Eliminating Retaining H-Plate; Revised to Native Voss Quick-Connect

- Cascadia and Cascadia Fifth GEN

PRIMARY EFFECT:

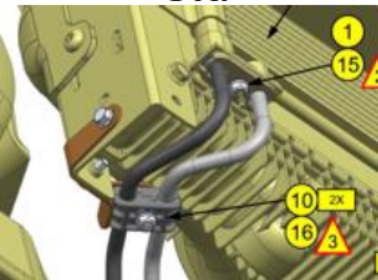
The current H-plate connection to transmission cooler is a blind installation process requiring tools. During the installation process of the male fitting, it is critical to achieve alignment or risk damaging the O-ring seal. This slight damage to the O-ring seal can't be detected unless you dis-assemble the connection & inspect the O-ring. If not corrected at assemble and the O-ring is damaged this can lead to a slow leak/ drip or wet spot at the connection that will collect dirt and debris.

VISUALIZATION:

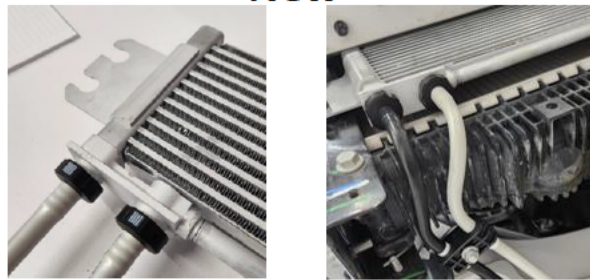
- 370 transmission coolers (Air to Oil) will be converted to integrated Voss style quick connect fittings.
- 383 lines will be revised to native Voss quick connect design eliminating a retaining H-plate & hardware.
- The new design will eliminate the need for tools & torque; this will make the process more robust, reduce assemble time & reduce the possibility of damaging the O-rings during assemble.

- Field kits to be made available including trans cooler and lines, 1 to 2 months after production in plants.
